**ADDENDUM NUMBER ONE (1)  
TO THE PLANS AND SPECIFICATIONS FOR:**

**NORTH ECHS  
AND  
COLLEGE & UNIVERSITY CAMPUS  
STUDENT RESTROOM RENOVATIONS**

**PSJA ISD  
Bid # 18-19-042  
Project No. 19.04**

GIGNAC & ASSOCIATES  
3700 N. 10<sup>th</sup> STREET, SUITE 205  
McALLEN, TEXAS 78501  
(956) 686-0100

**BUILDING E**  
**DEMO PLAN**

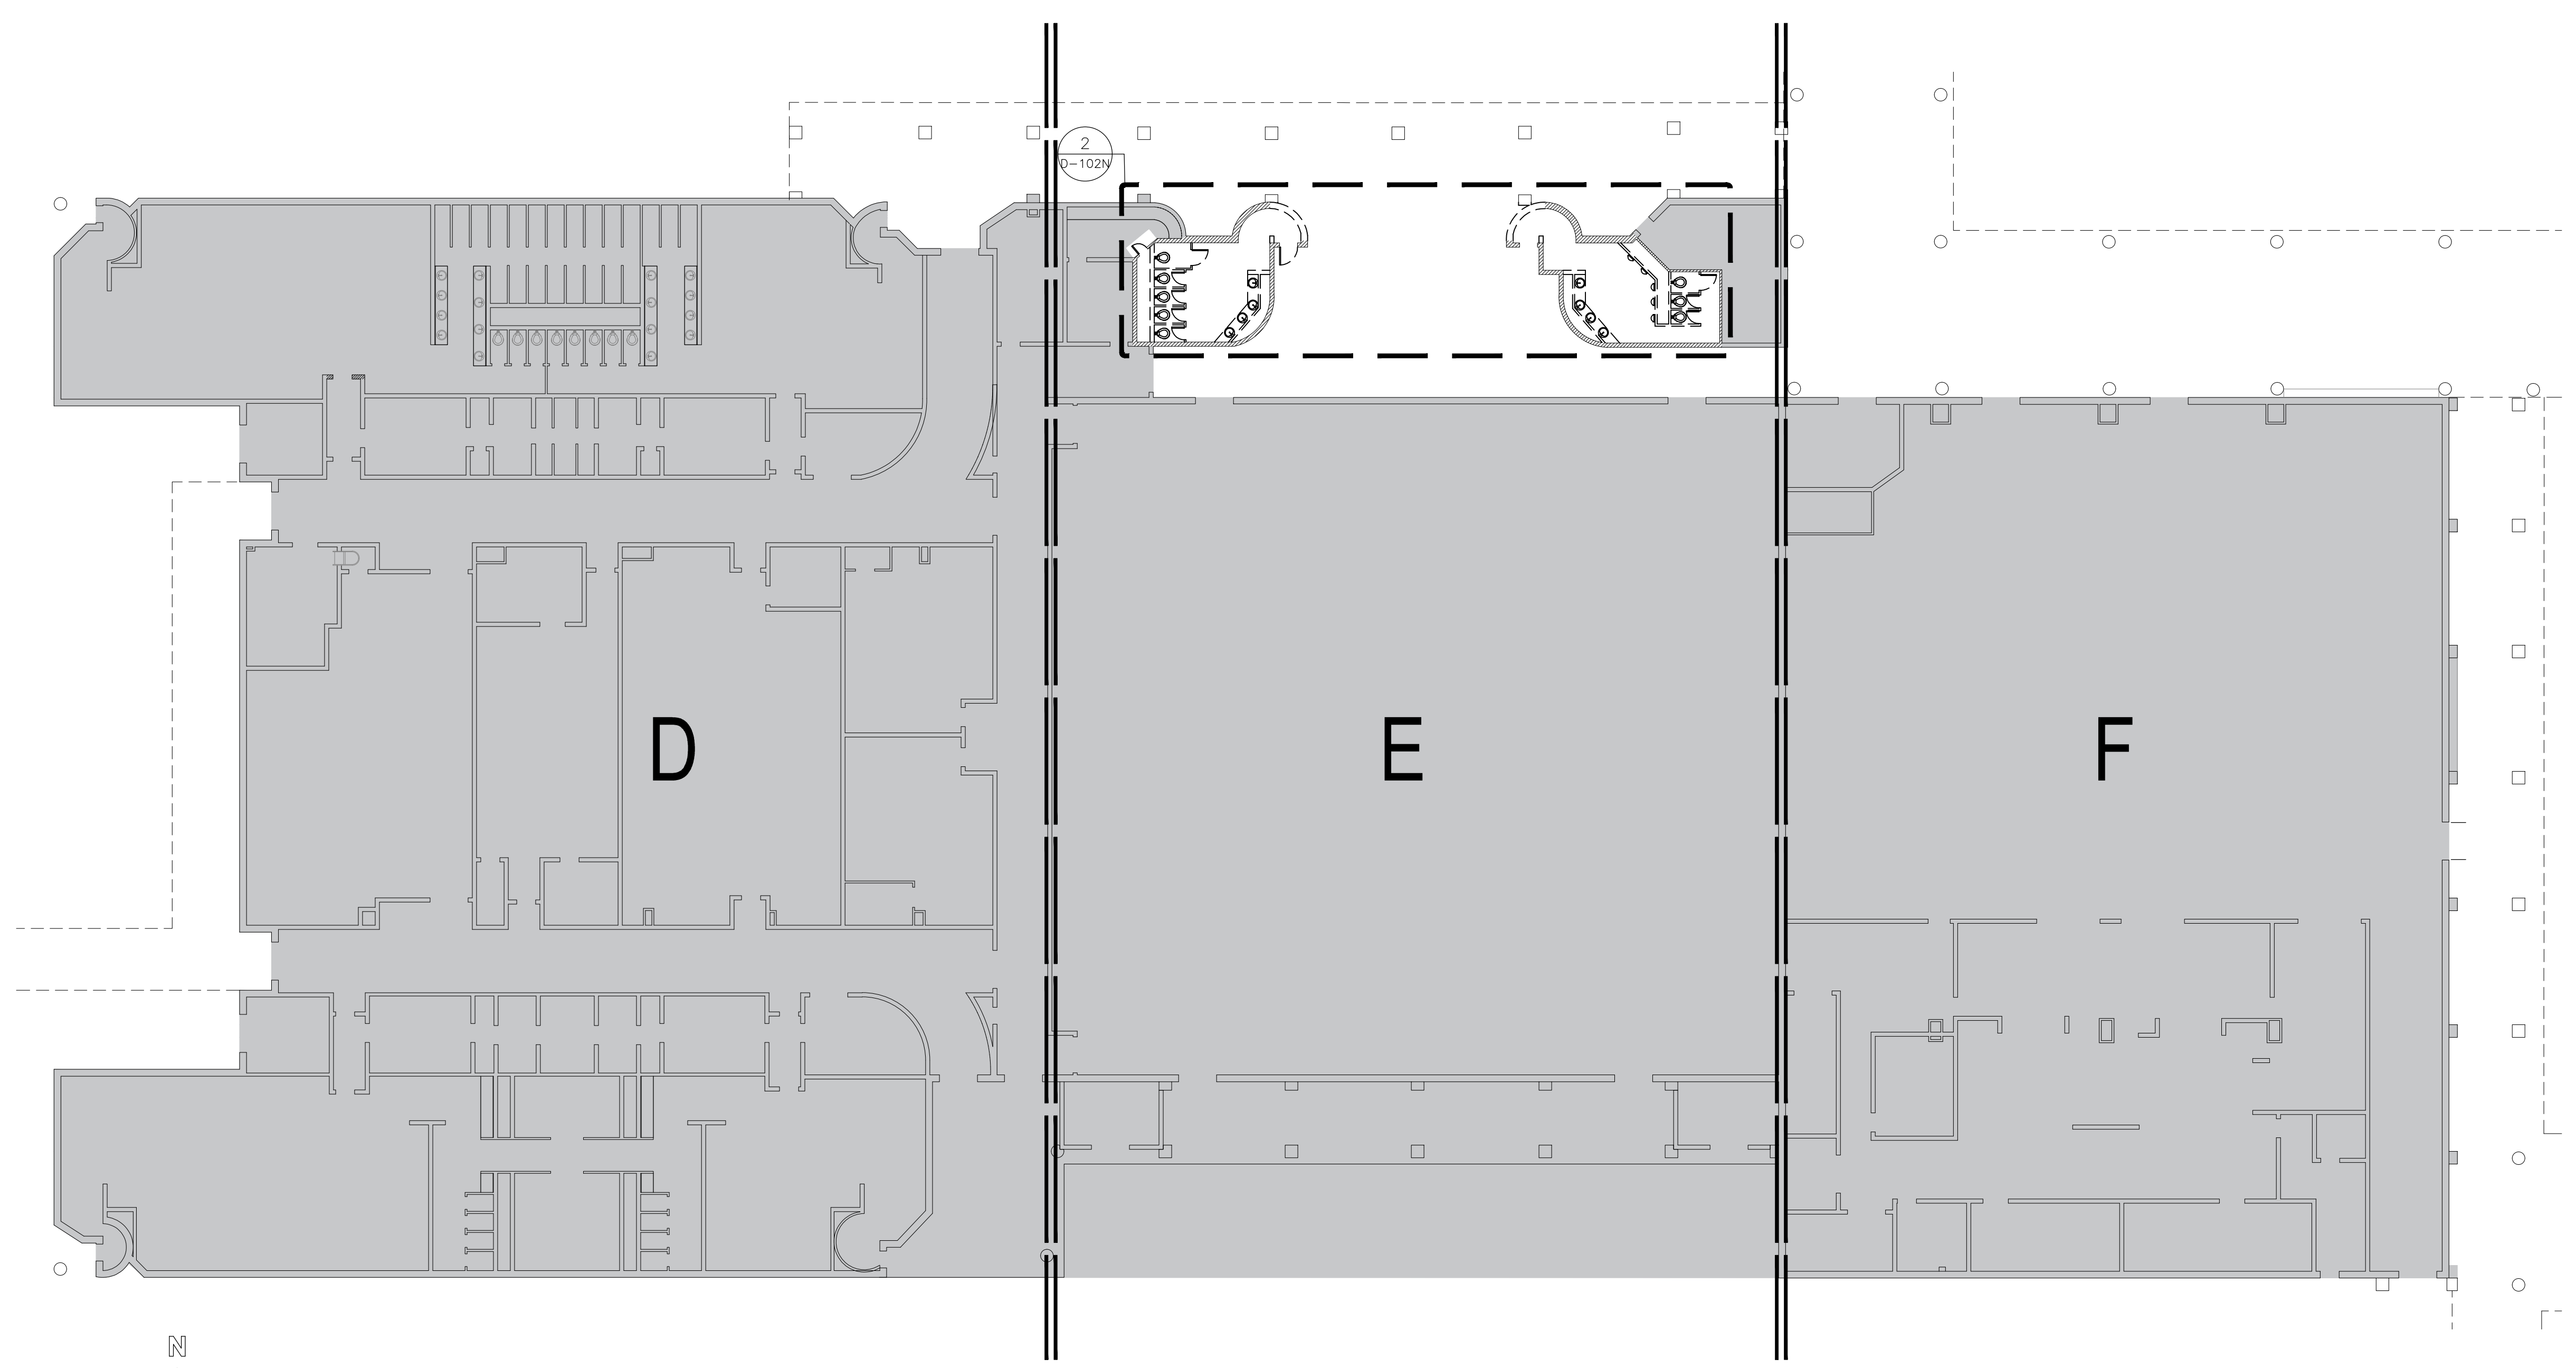
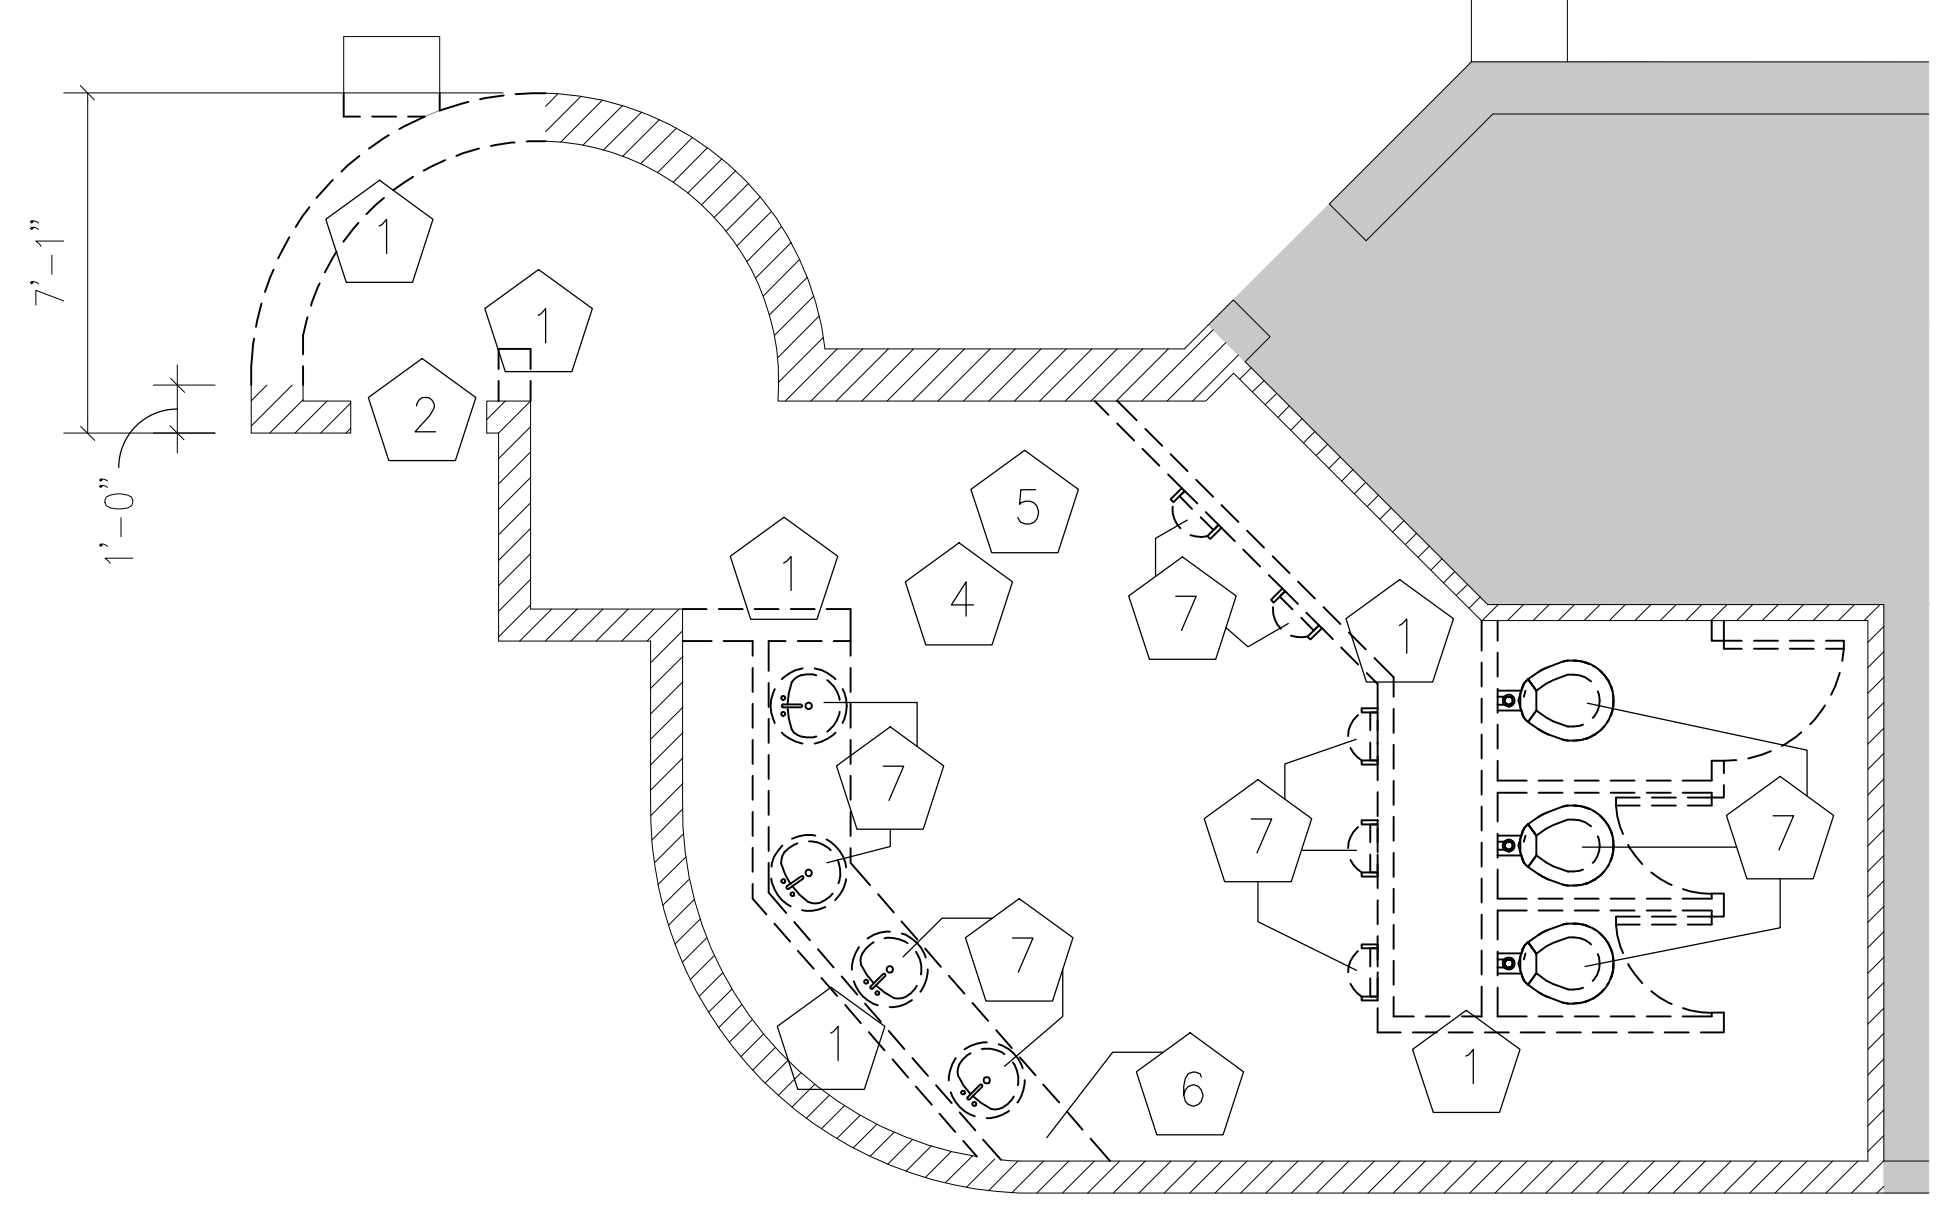
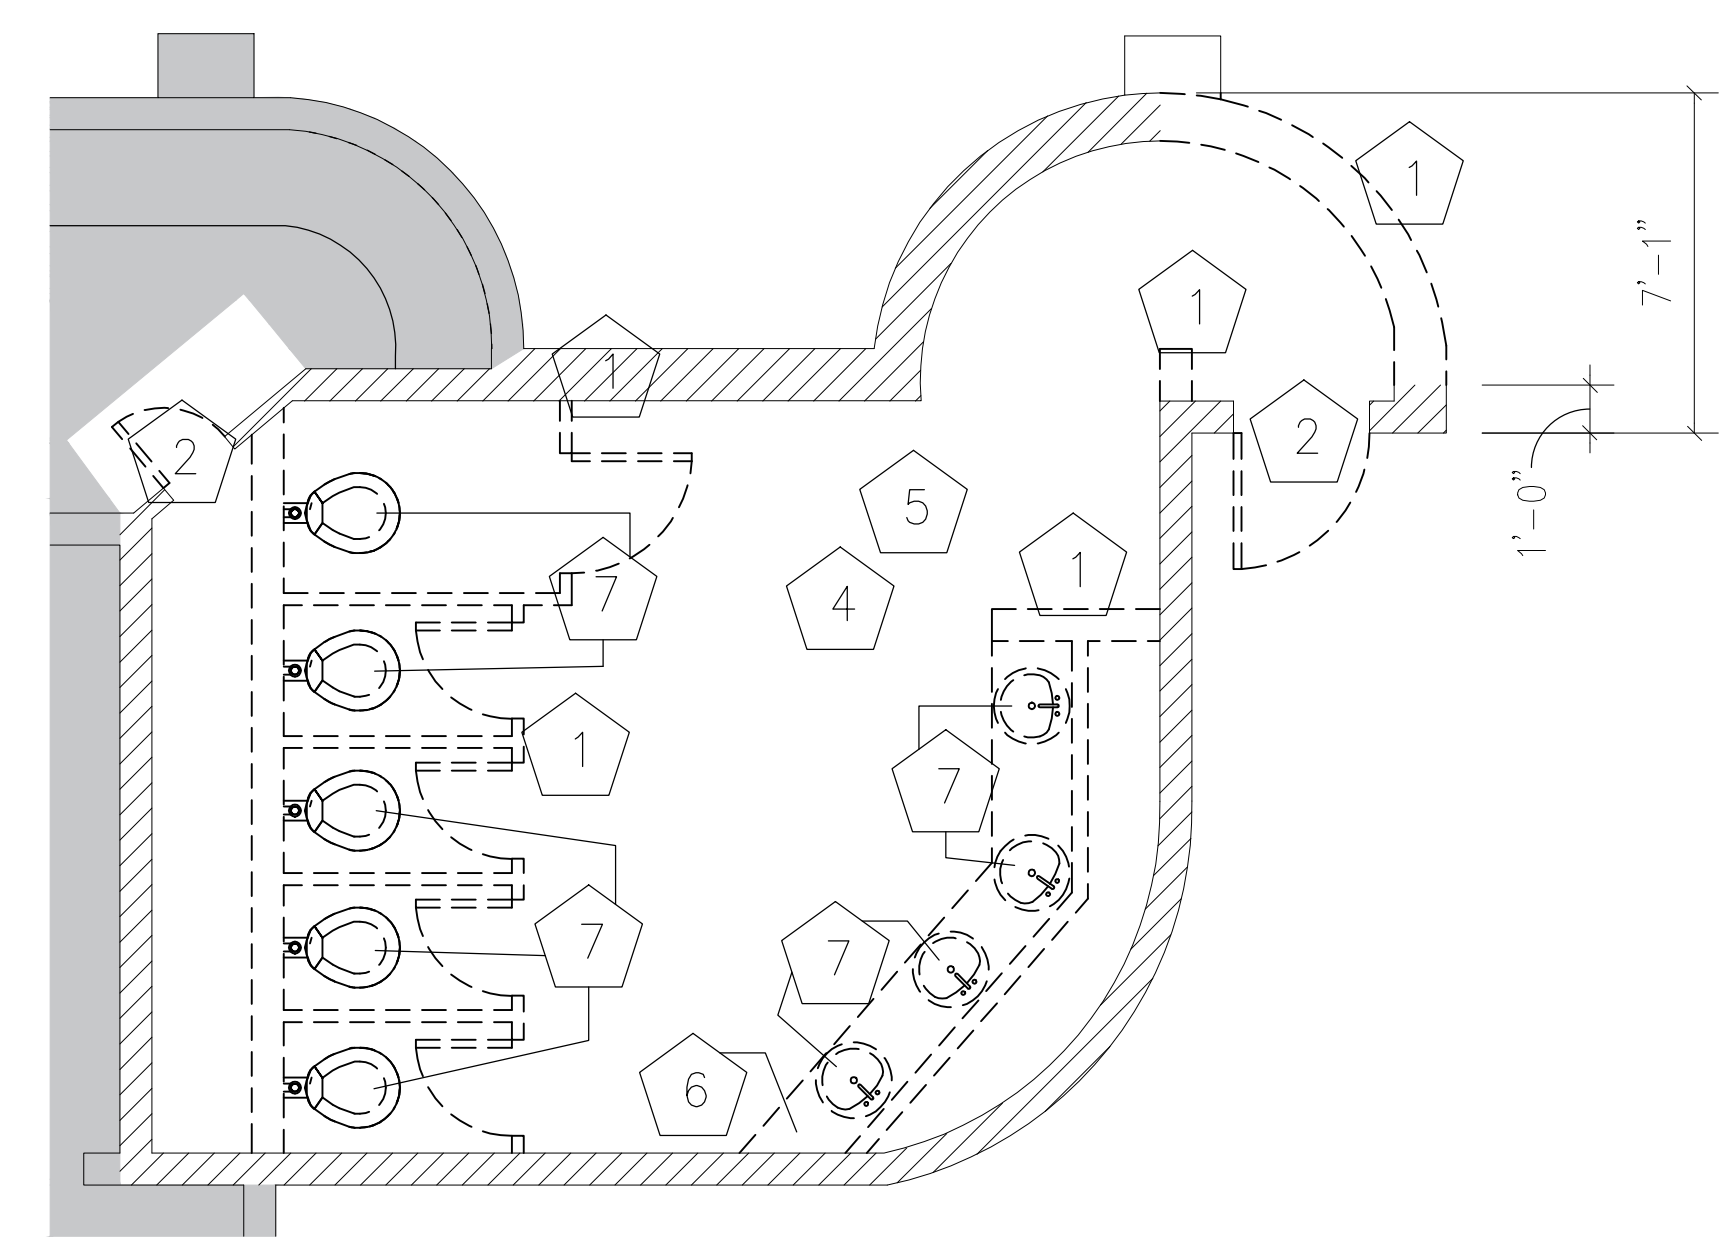
Sheets D-100N to D-106N included in this Addendum shall replace their respective sheets in the Contract Documents. The following sheets provide additional dimensions for further clarification.
